Development Permit Panel

2. Development Permit 10-556148

APPLICANT: Gagan Chadha

PROPERTY LOCATION: 9131 and 9151 Williams Road

CONVERTIBLE UNIT PLAN
UNIT Aa (BLDG. NO. 1)

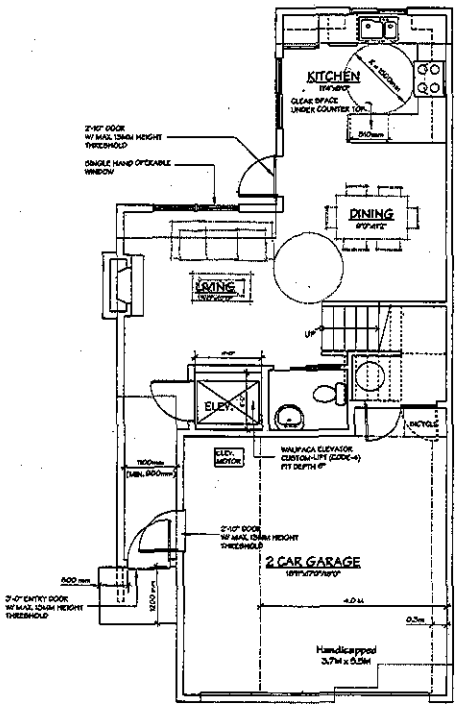
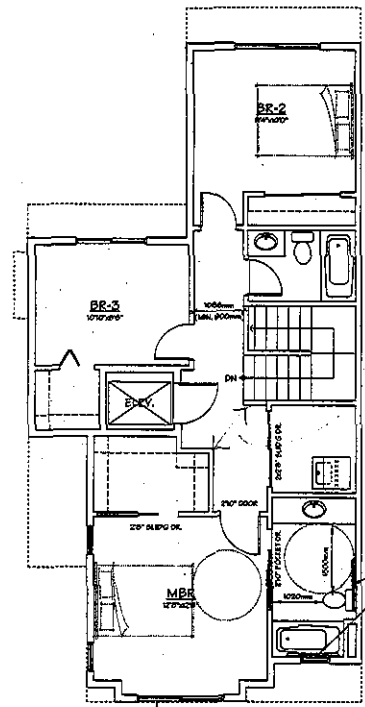
is this appropriate for wheel chair operation?
